Year 4 Monitoring Report
Final
Greenbrier Stream Mitigation Project
Yadkin County, North Carolina
Monitoring Year 4

NCDEQ Contract No. 7616
DMS ID No. 100086
USACE Action ID No. SAW-2018-01755
NCDWR ID: 20181272
Yadkin River Basin
HUC 03040101

**RE: Response to Draft MY4 Monitoring Report Comments dated December 13, 2023
Greenbrier Stream Mitigation Site
Yadkin River Basin – CU# 03040101 - Yadkin County, North Carolina
NCDMS Project # 100086, Contract # 7616**

GREENBRIER STREAM RESTORATION SITE
CURRENT CONDITION PLAN VIEW: ASSET MAP
MY4: 2023

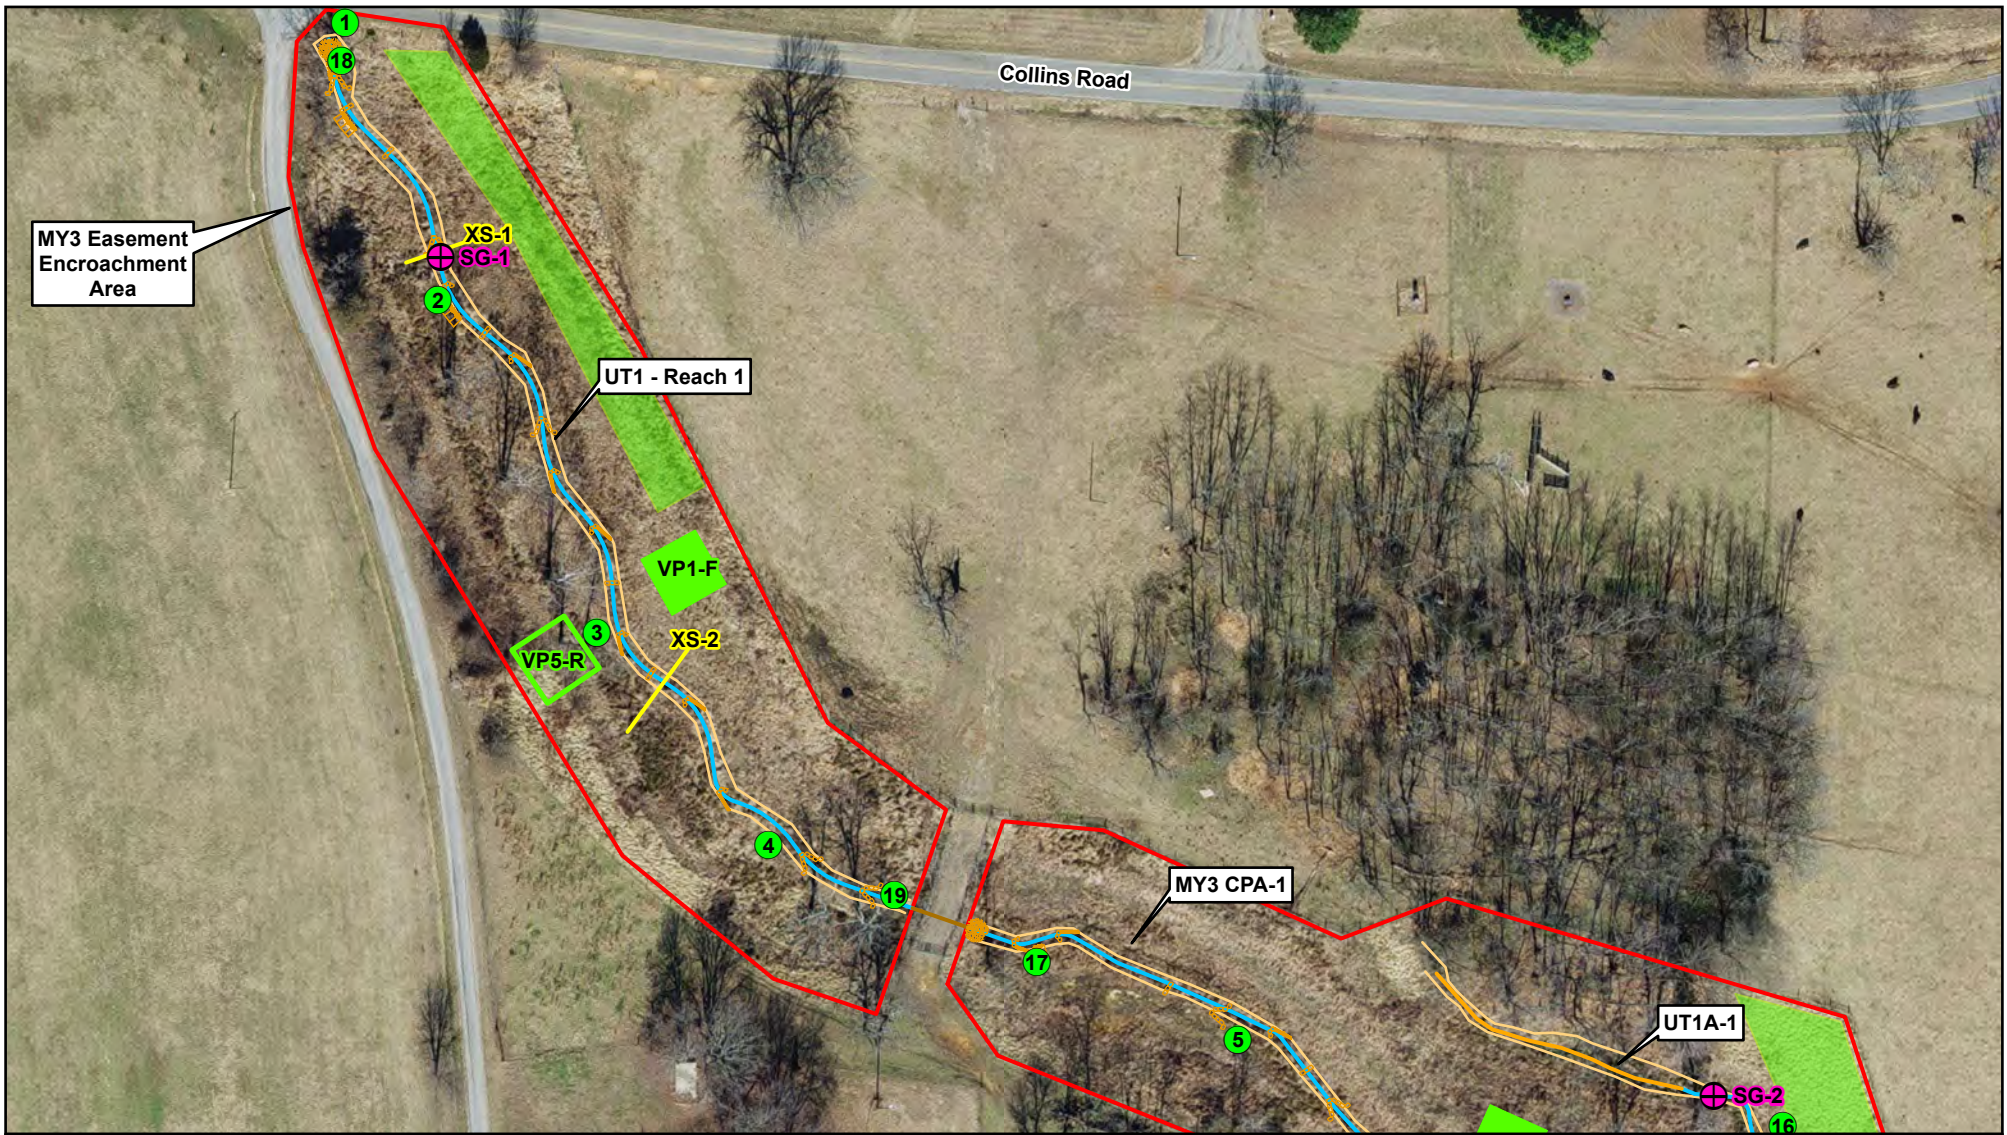
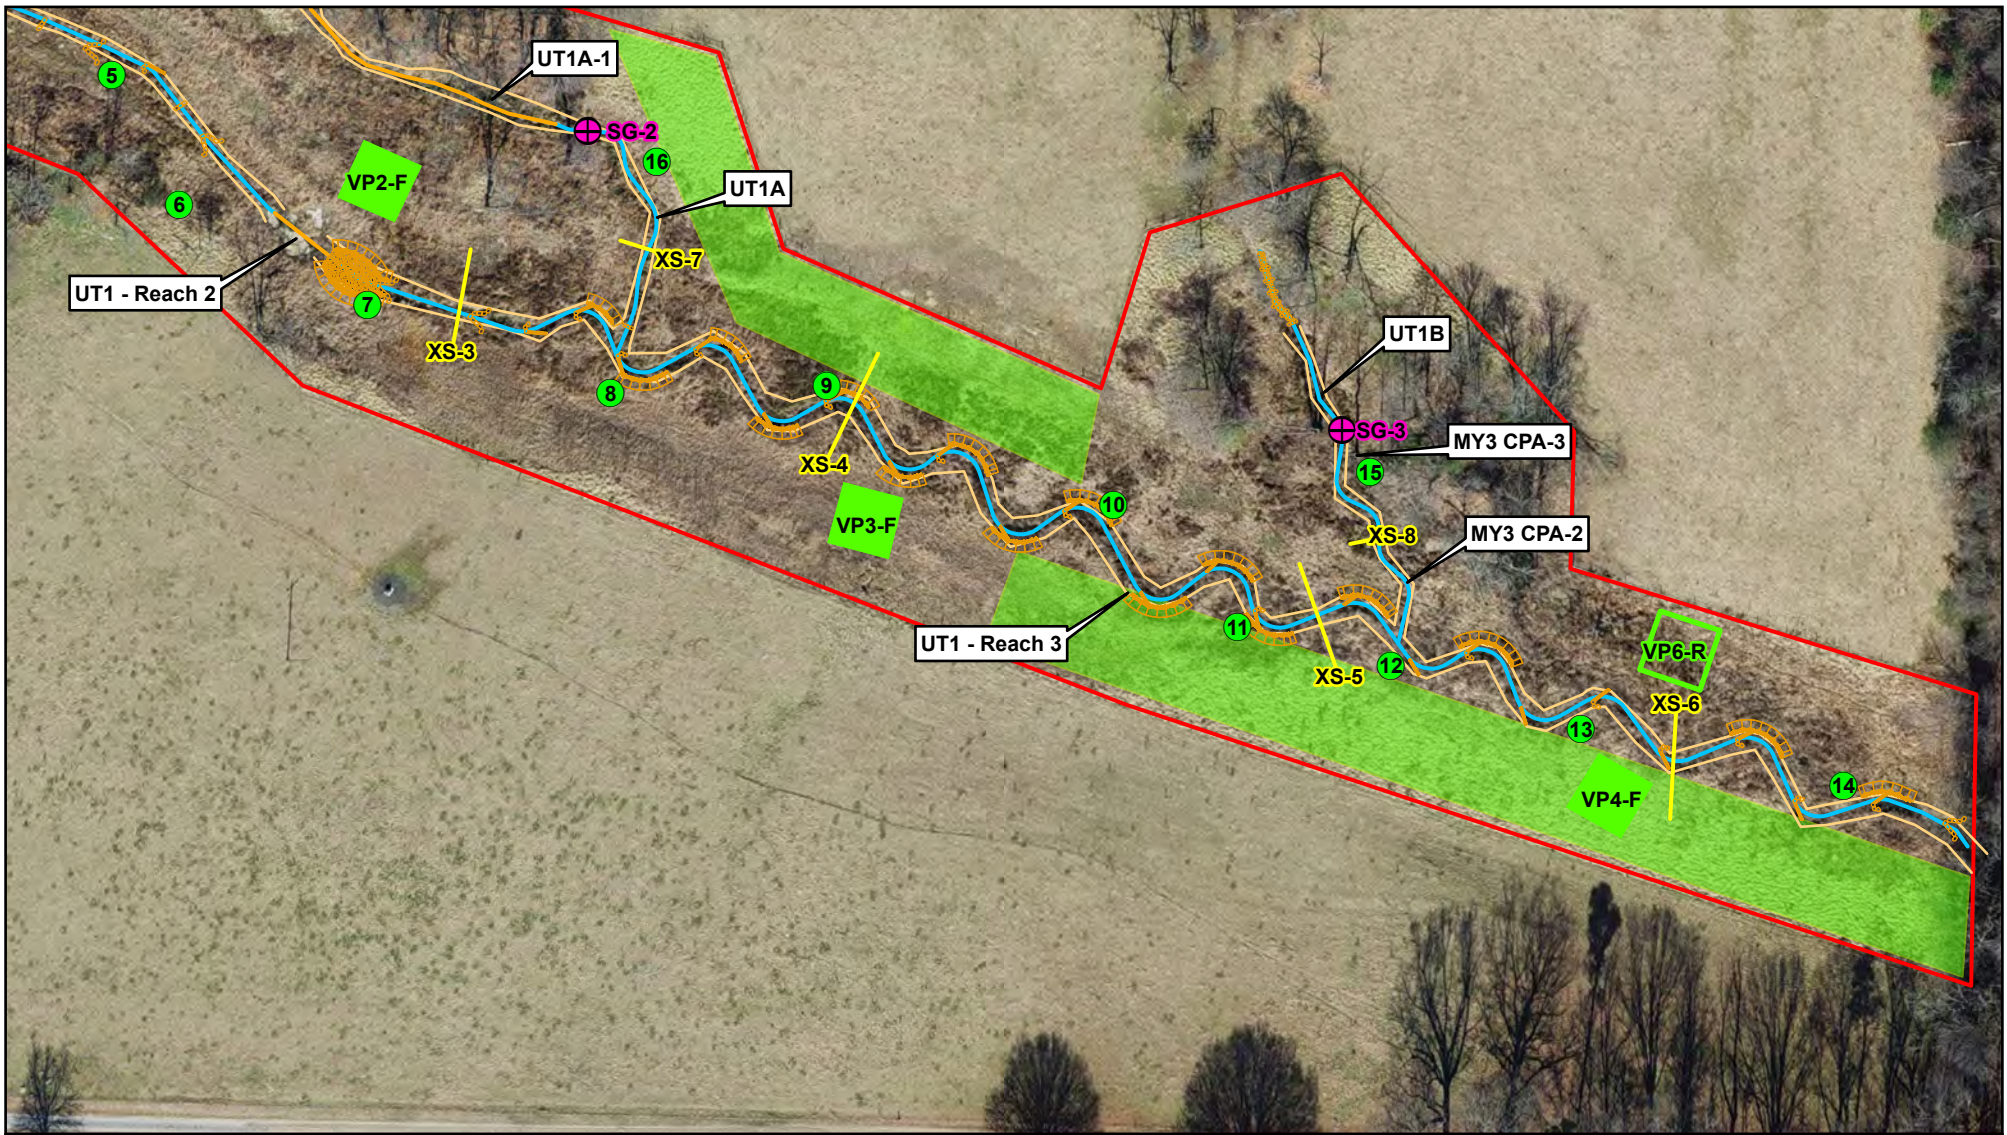
Section 2.1.3 Channel Stability: In the report text, please briefly reference MY3 CPA-3 as shown on the CCPV map/s. The report text addresses the lower extent of UT1B but the MY3 CPA-3 callout should be referenced in the text.

- **MY3 CPA-3 is briefly referenced in section 2.1.3 Channel Stability, paragraph four.**

2023 (MY4) Supplemental Planting list and Location Map

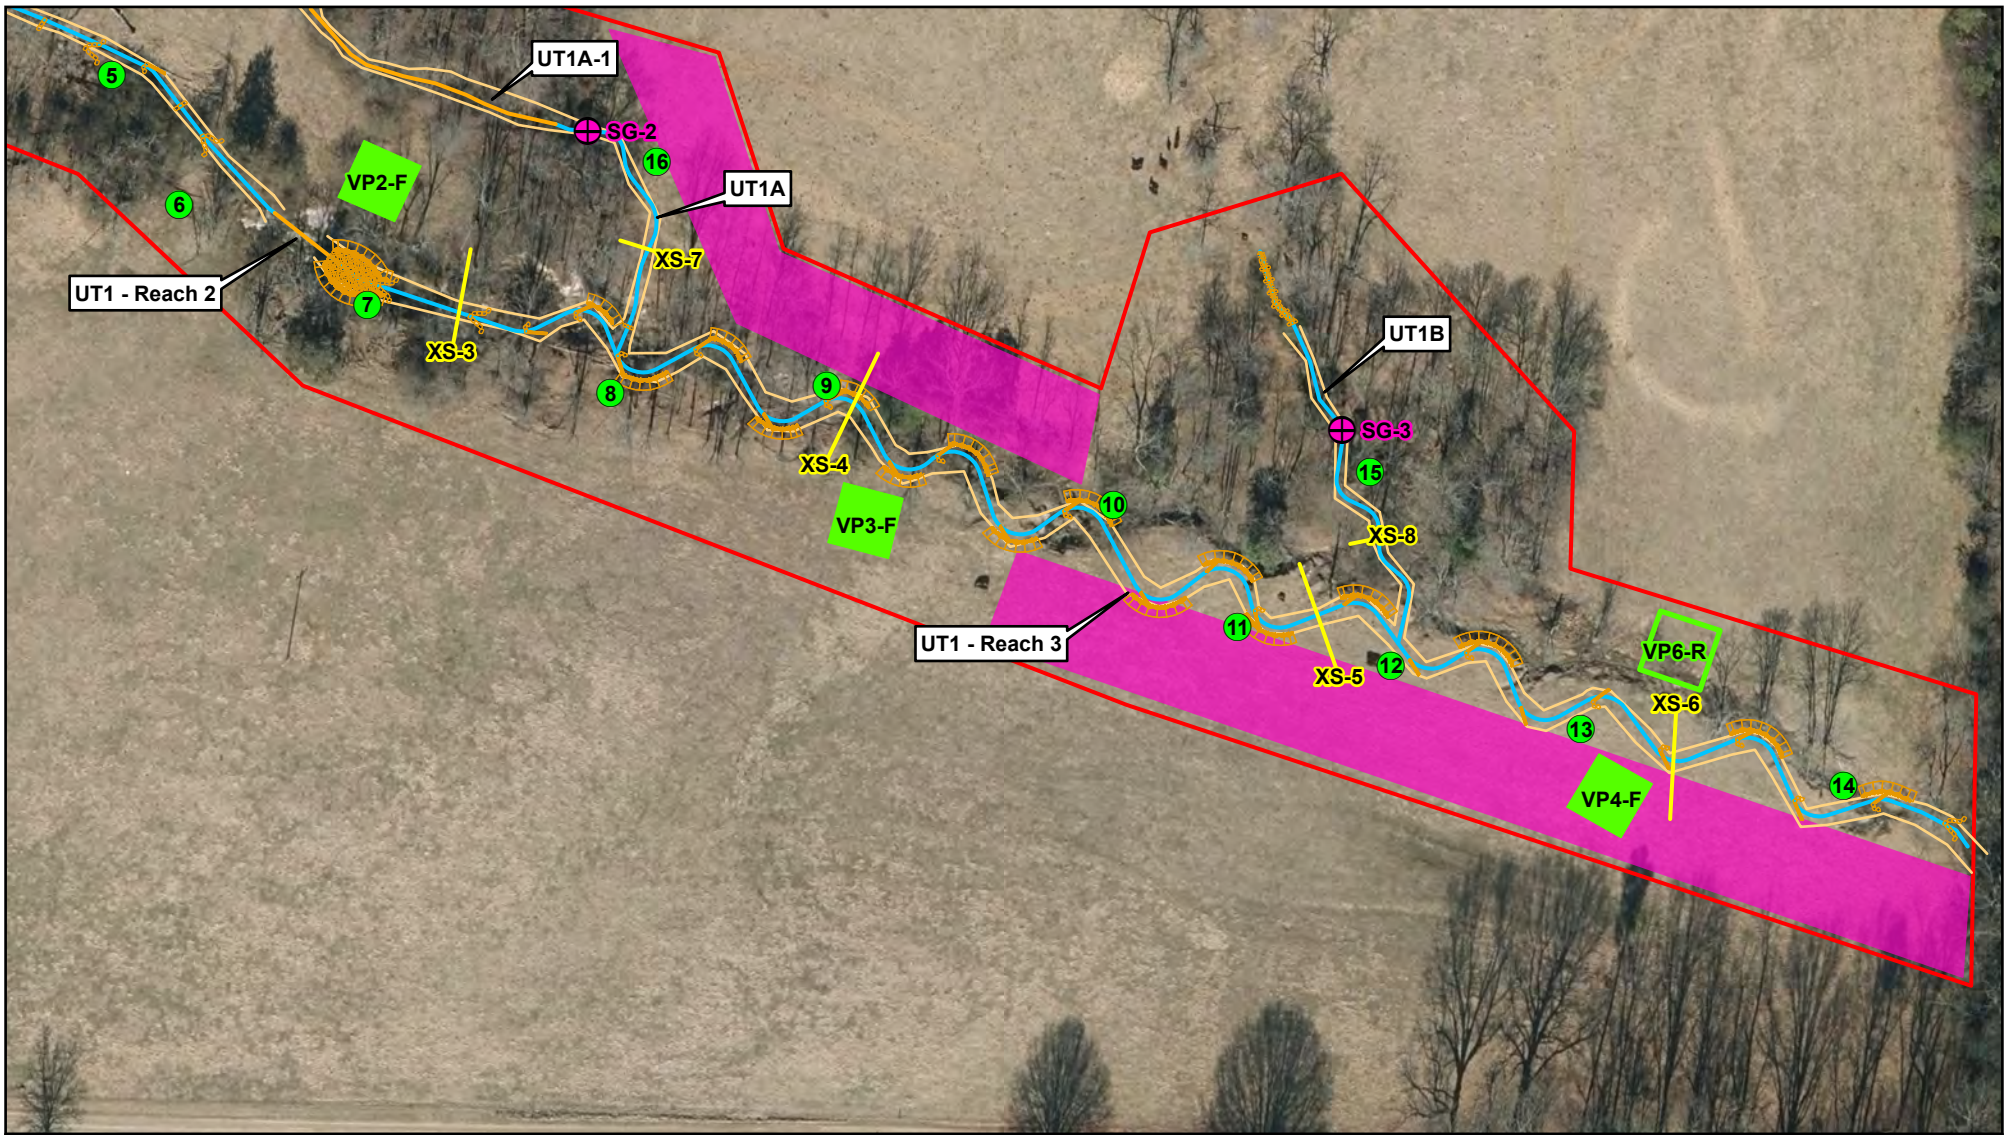
Section 2.1.3 Channel Stability: *“To expedite stream shading and stabilization, EPR planted additional live stakes along both UT1A and UT1B in January 2023.”* Please include the species of live stakes installed in MY4 (2023).

General / Appendix B: In the revised report, please include a supplemental planting list/ table for the January 2023 (MY4) planting effort. The list/ table should be similar to the provided Greenbrier 2021 Supplemental Planting Species List and should include a wetness tolerance column.

- **The supplemental planting list and location map for MY4 (2023) is attached in appendix B in this report.**

- **A supplemental planting species list and wetness tolerance column is attached in appendix B.**
